Agenda

Planning Committee Meeting Thursday 3 September 2015

ITEM	PRECIS	PAGE
	REPORTS THROUGH THE GENERAL MANAGER	6
	REPORTS FROM THE DIRECTOR PLANNING AND REGULATION	6
1	[PR-PC] Development Application DA14/0904 for a 28 Townhouse Development at Lot 2 DP 566095; No. 47 Champagne Drive Tweed Heads South	6
2	[PR-PC] Coastal Villages Planning Proposal and Amendments to Tweed Development Control Plan - Section B23 Hastings Point	82
3	[PR-PC] Tweed DCP 2008 - Draft Amendment B28 - Club Banora	95
4	[PR-PC] Unauthorised Activities at Lot 22 DP 585033 No. 51 Phillip Street, Chinderah	104
5	[PR-PC] Variations to Development Standards under State Environmental Planning Policy No. 1 - Development Standards	111

DRAWING NO.
DA-13

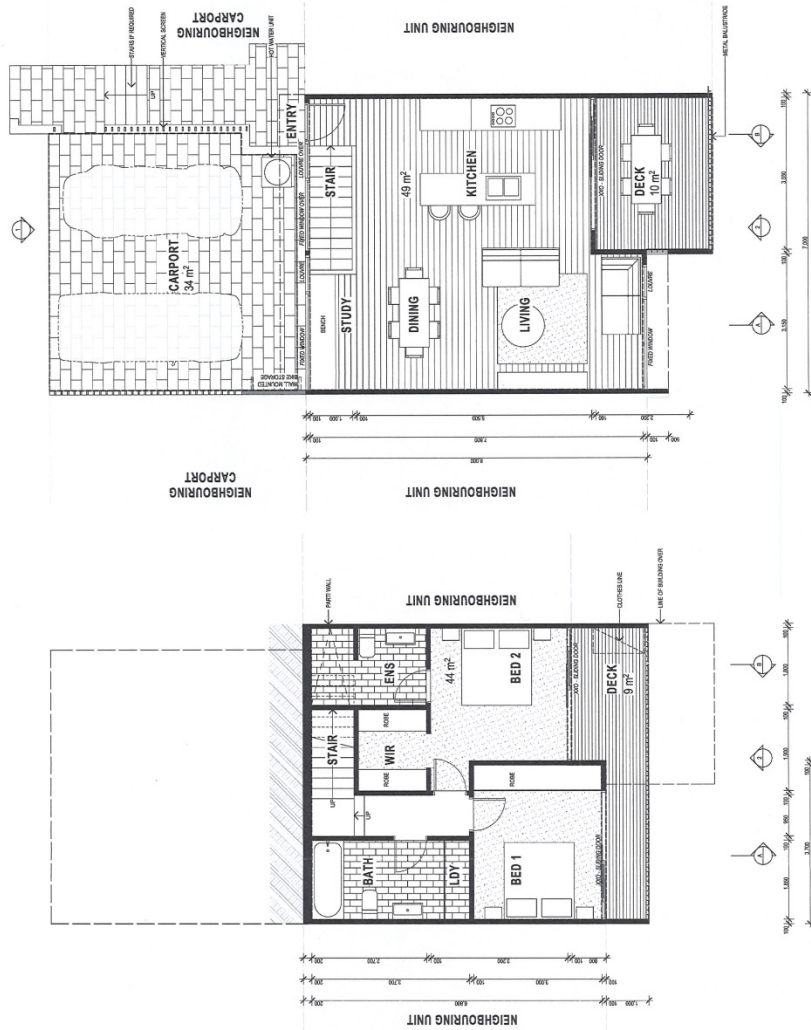
The amended plans for Dwellings 1-13 (dwelling type A), still requires a cut of between 1.5m to 2.85m and also includes the construction of part of the lower level being built below natural ground level. The development of Dwelling Type A does not offer any form of stepping or suspended flooring to accommodate the changes in level.

Site View 1 - Development Context & View Corridors

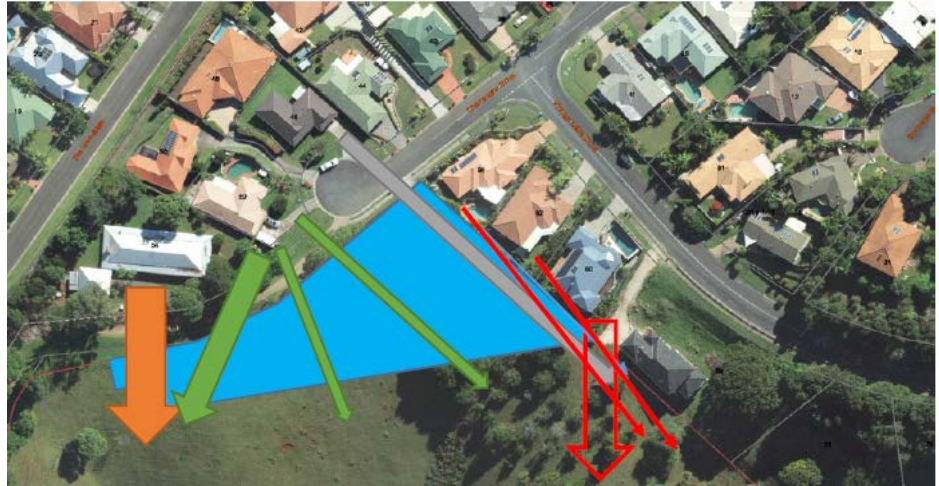
The redesign submitted to Council in response to Council's request for further information (whilst reducing the required cut for the proposed development) has proposed to bring the footprint for the proposed dwellings 1-13 further up the site, which results in a further impact on the existing views from the Champagne Drive area and existing dwellings.

The location of the proposed development is also considered to have a visual impact from the opposing ridgeline and surrounding residential area, in response to the bulk of the development (this is discussed further within this report).
